KERRY et al
Appl. No. 10/594,678
April 10, 2008

AMENDMENTS TO THE DRAWINGS

ANNOTATED MARKED UP DRAWINGS
FOR SN 10/594,678

FIGURE 1
(PRIOR ART)

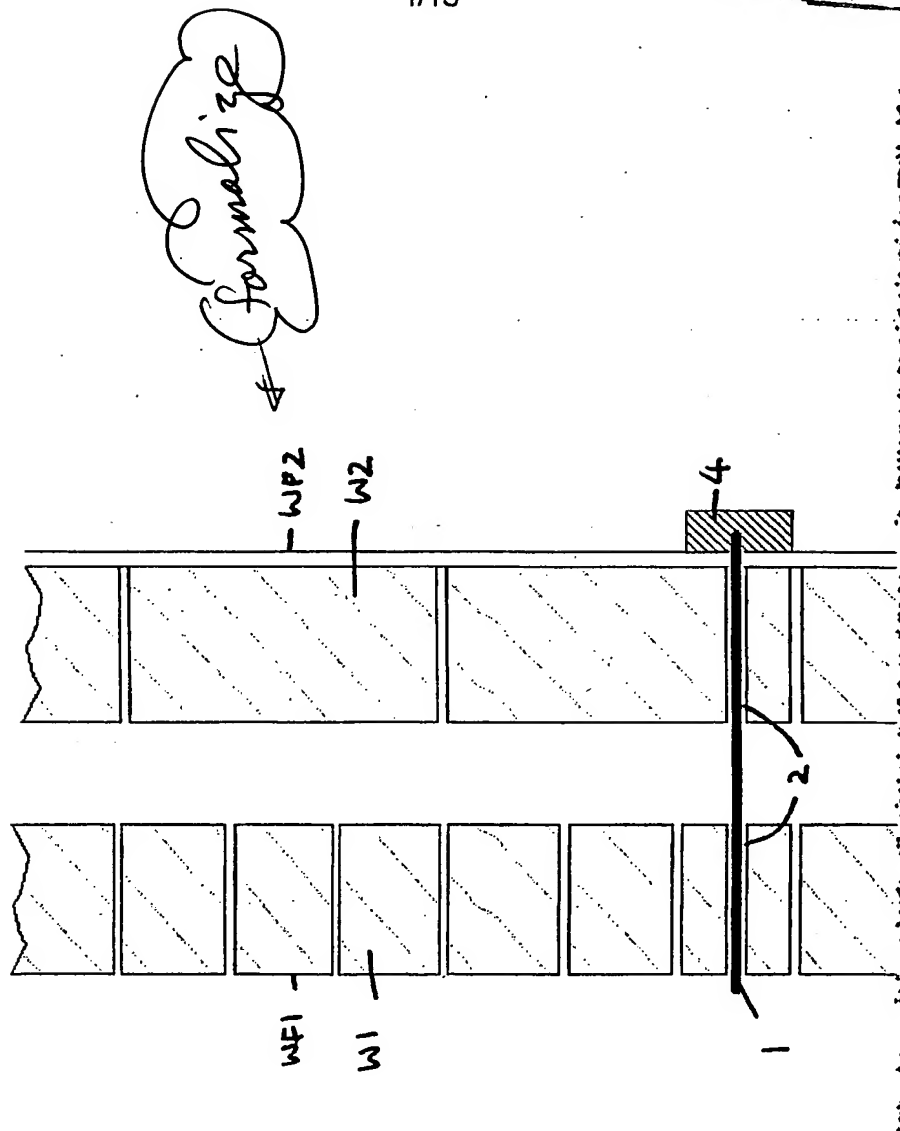
The drawings have been amended to add the "Prior Art" legend to Figures 1-2 as requested. In addition, the drawings have been otherwise "formalized".

FIGURE 2 A
(PRIOR ART)

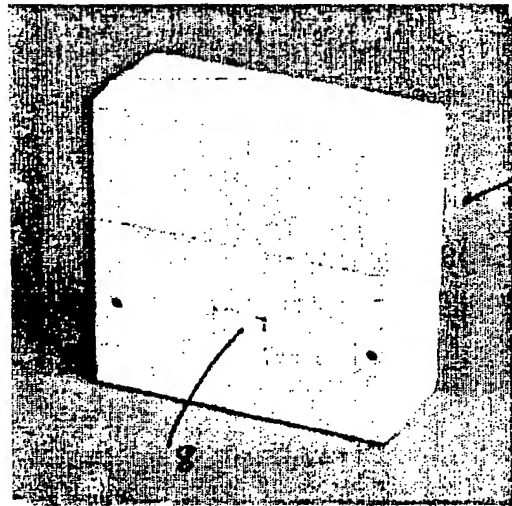
clean up

formalize

FIGURE 3

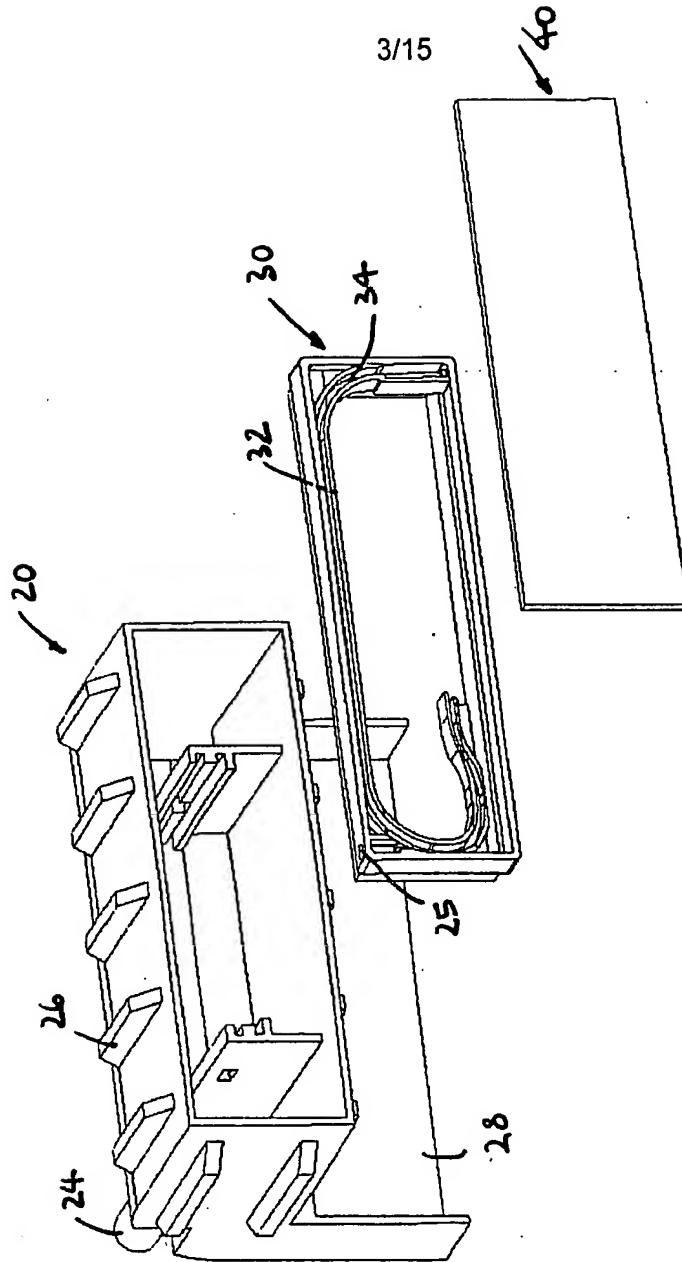
Formalize

FIGURE 4

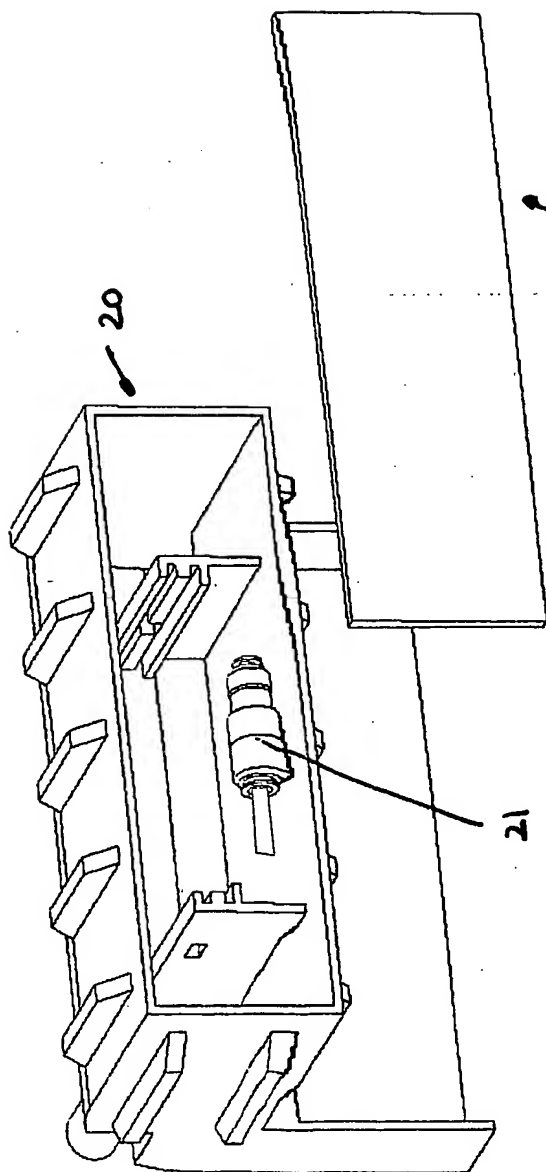
Formalize

FIGURE 5A

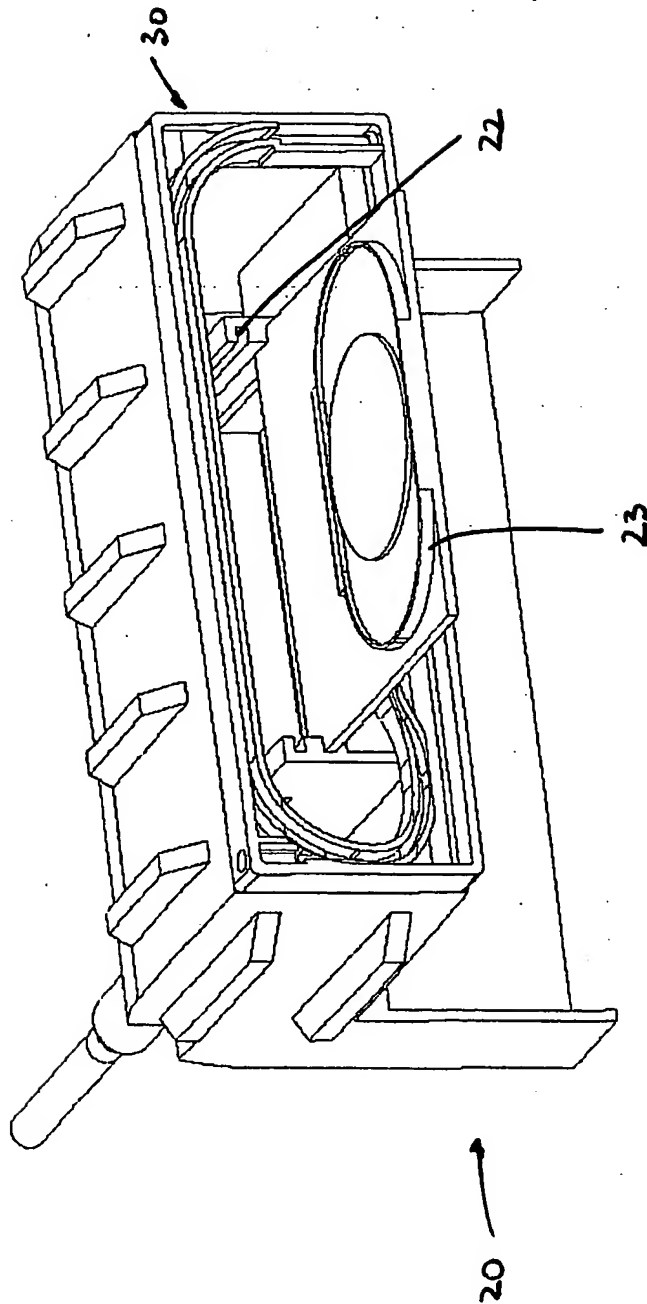
formalize

FIGURE 5B

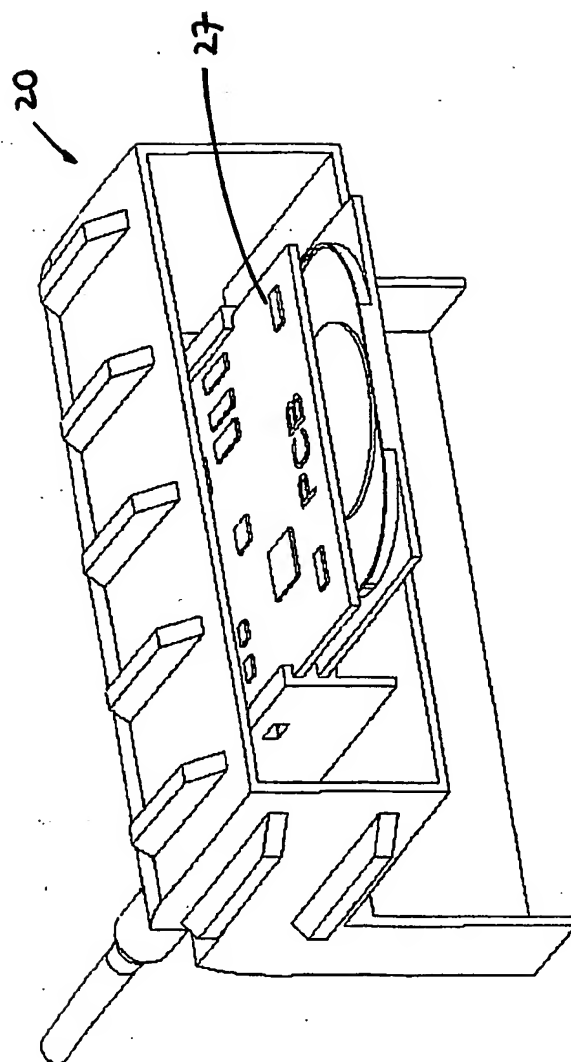
Formalize

FIGURE 6

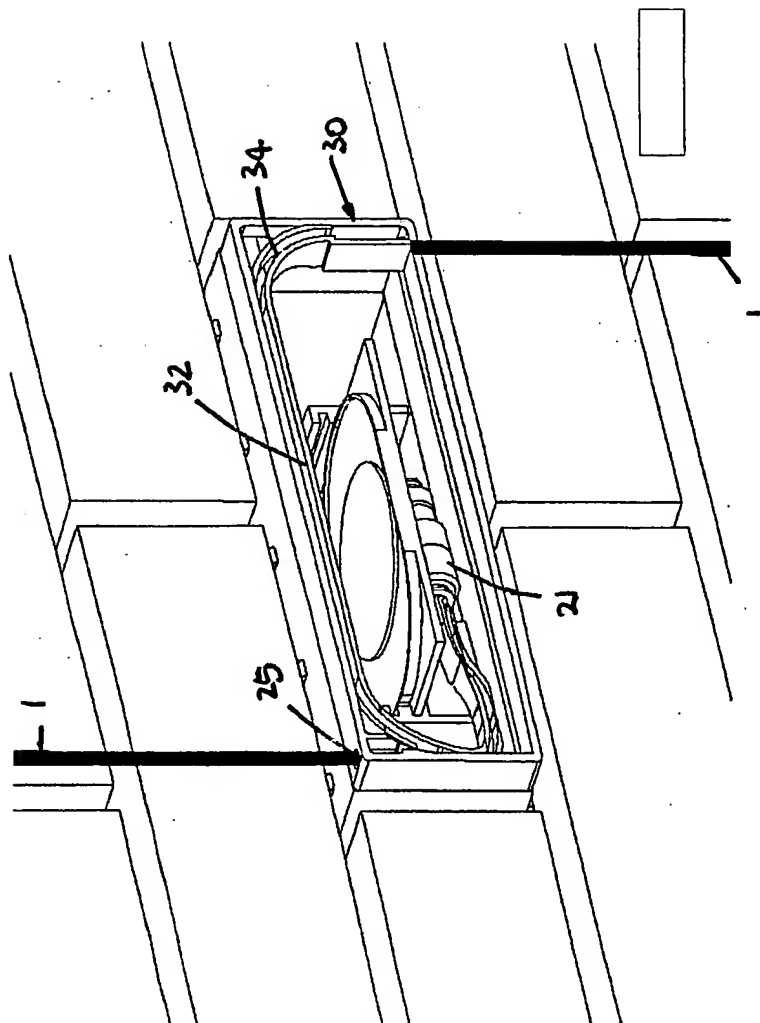
Formalize

FIGURE 7A

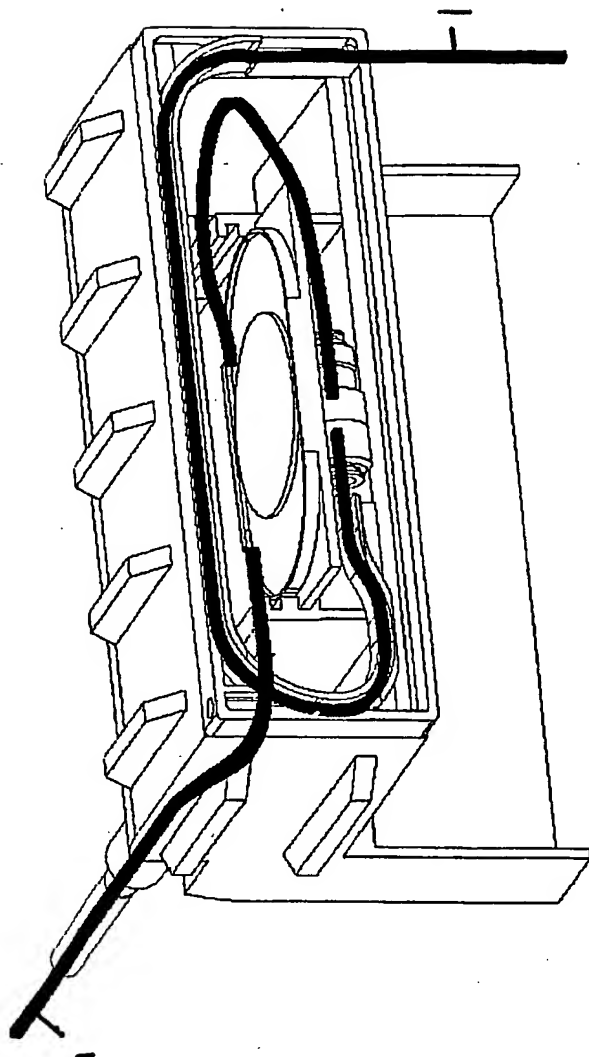
formalize

FIGURE 7B

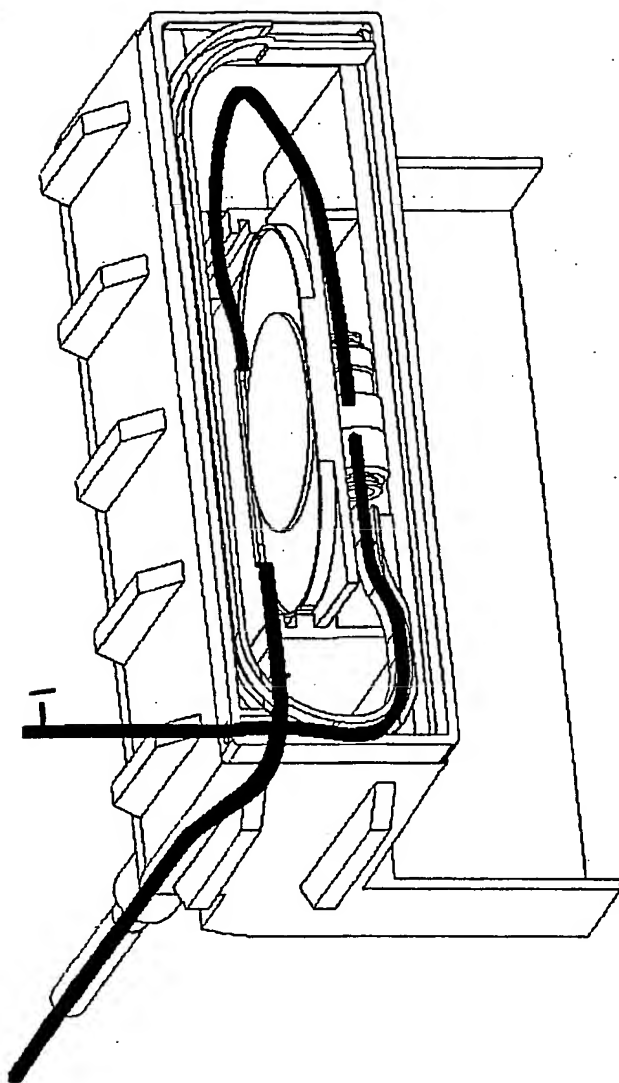
formalize

FIGURE 8

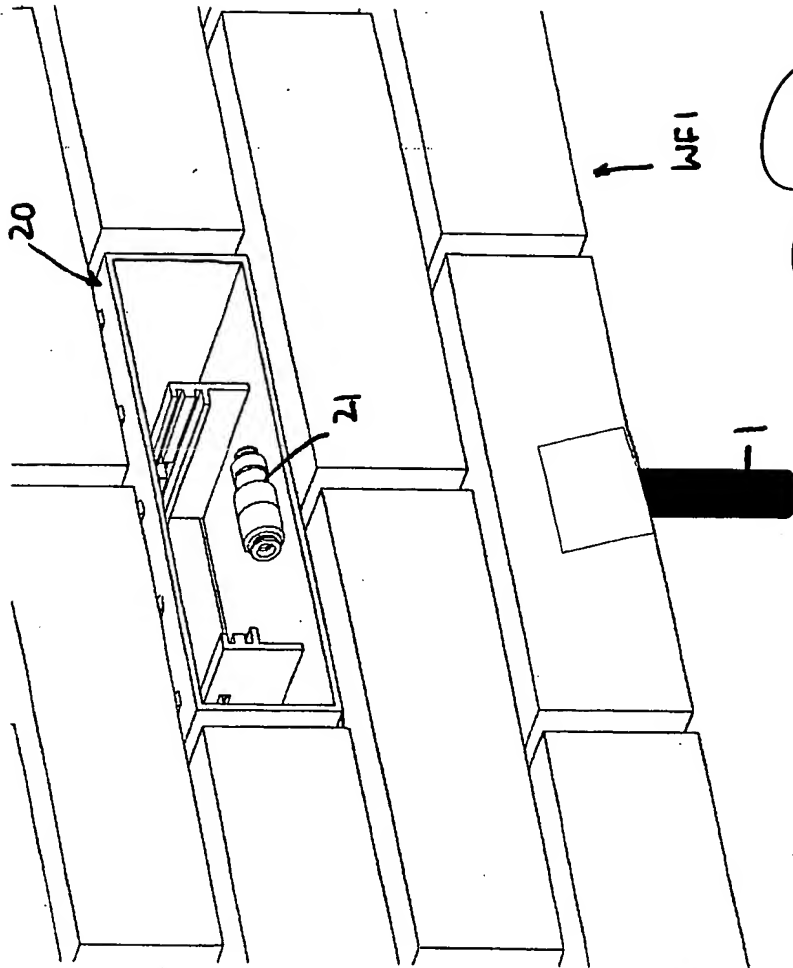
Formalize

FIGURE 9

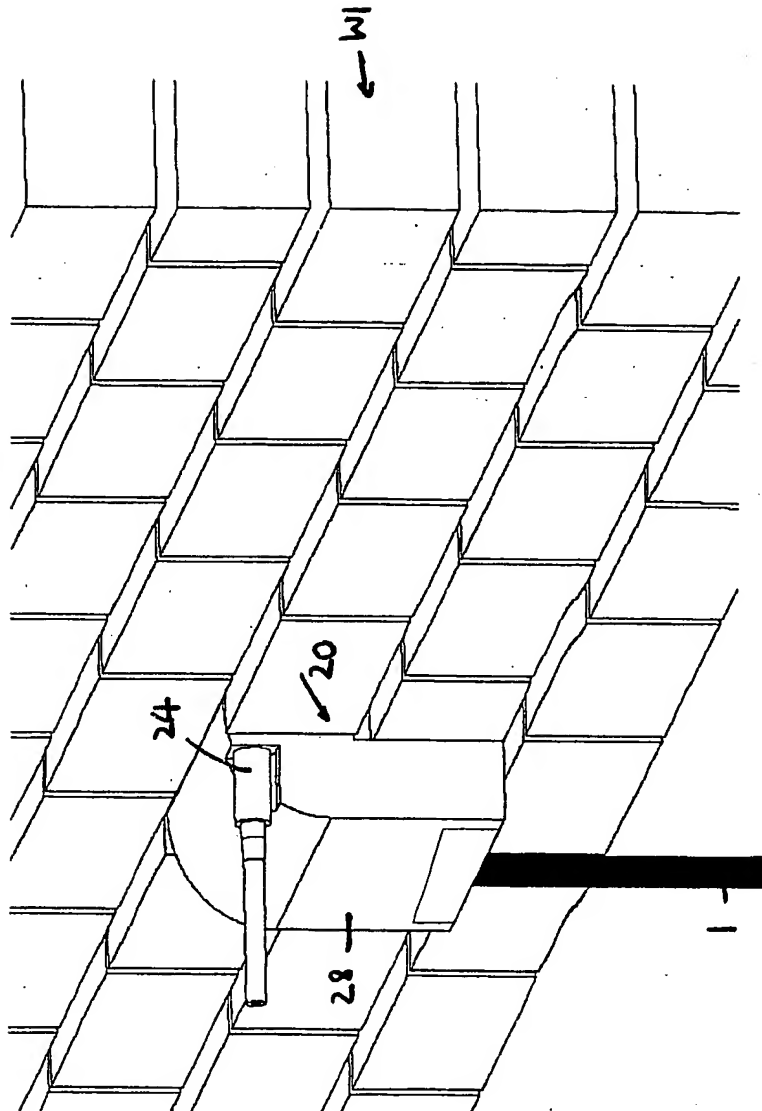
formalize

FIGURE 10B

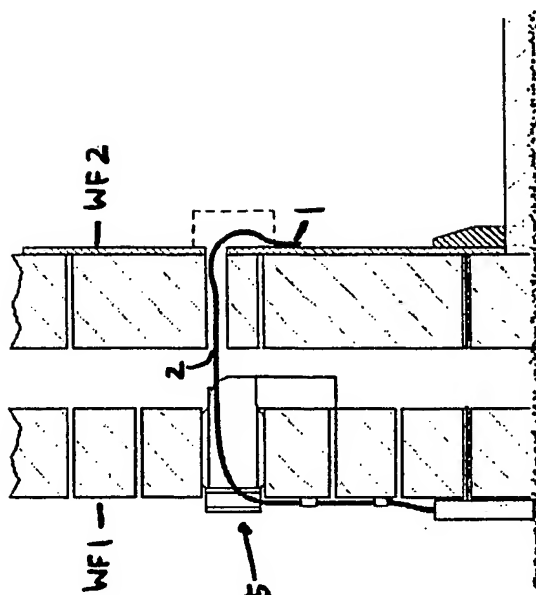
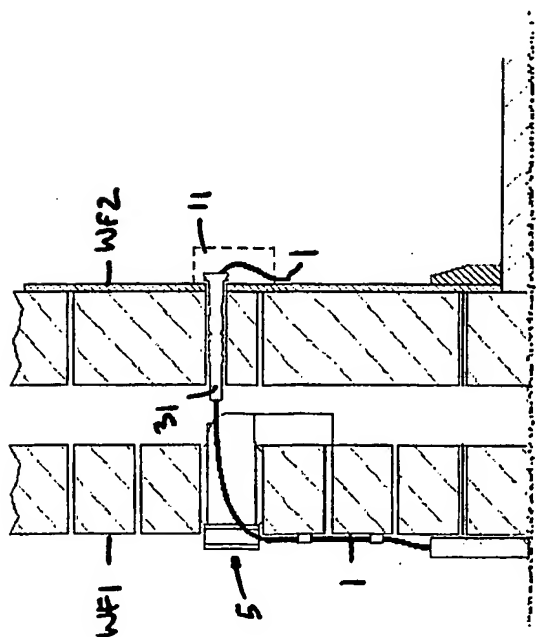
formalize

FIGURE 11B

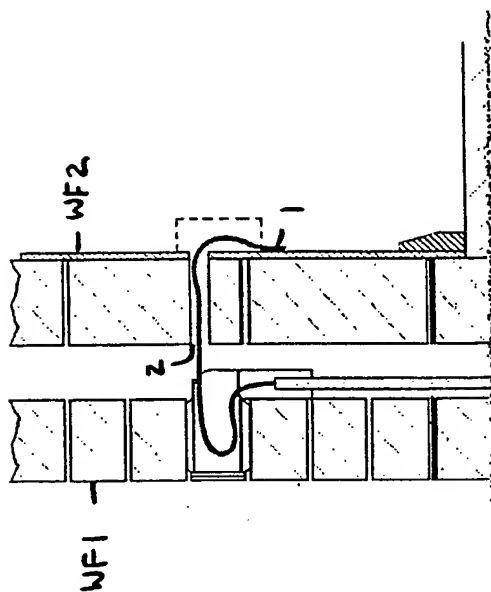
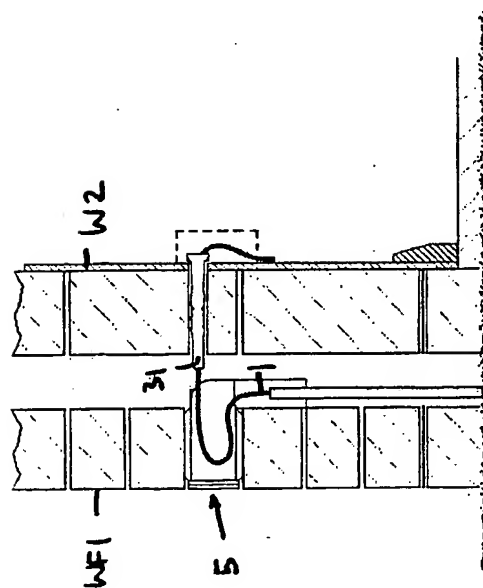
formalize

FIGURE 12

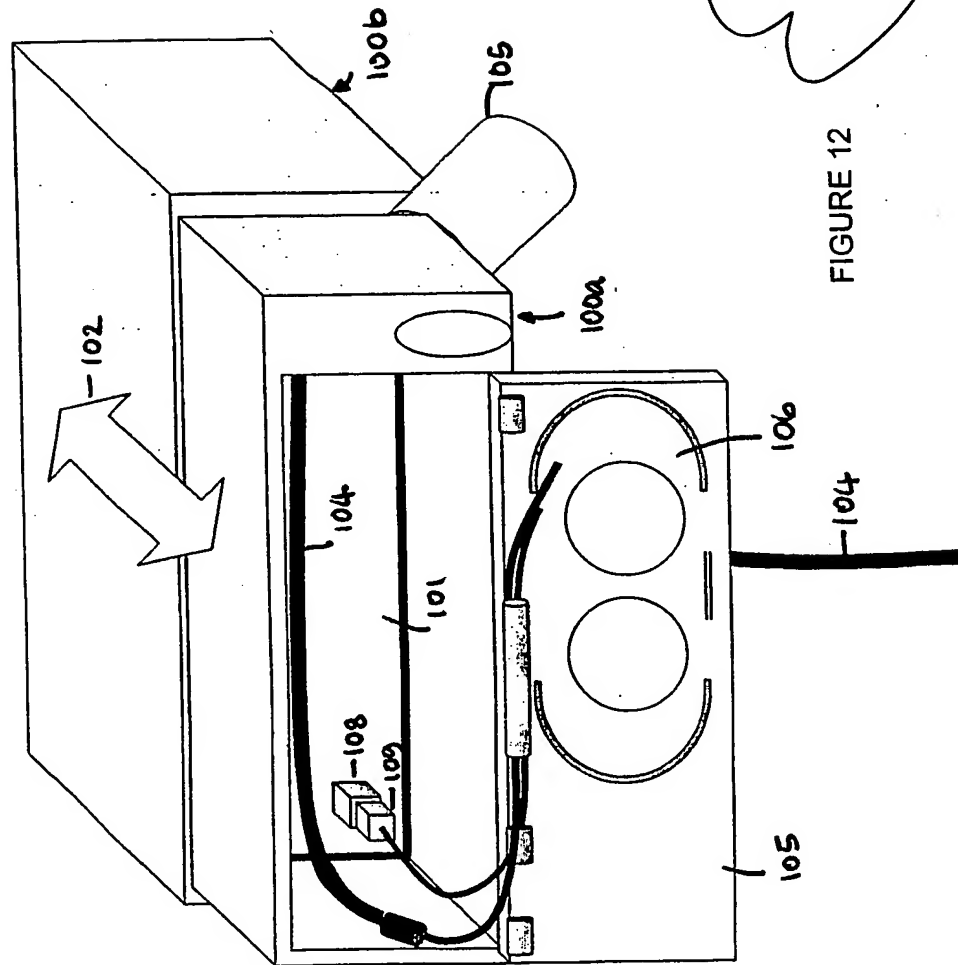
Formalize

FIGURE 13

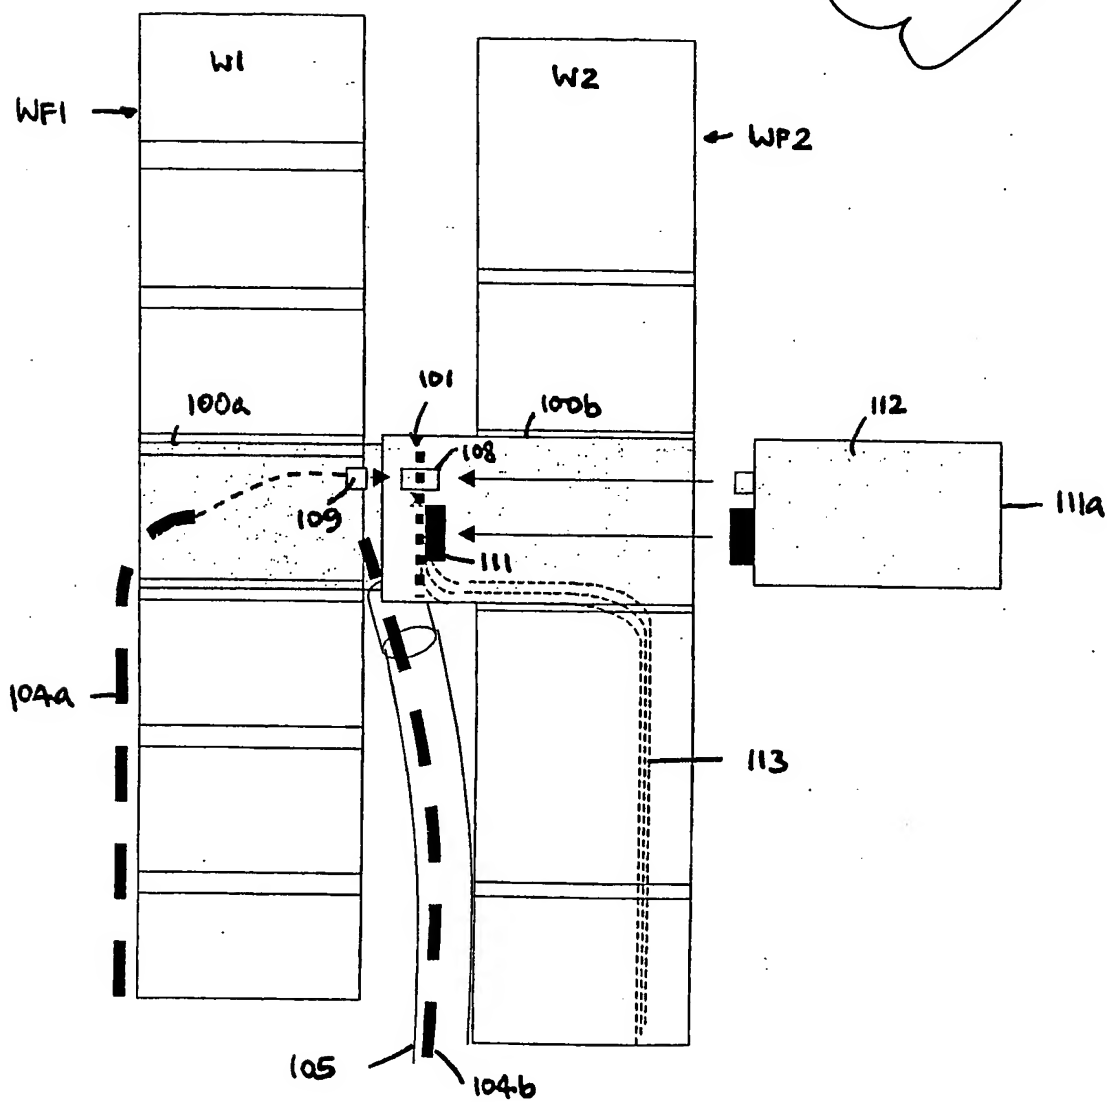
formalize
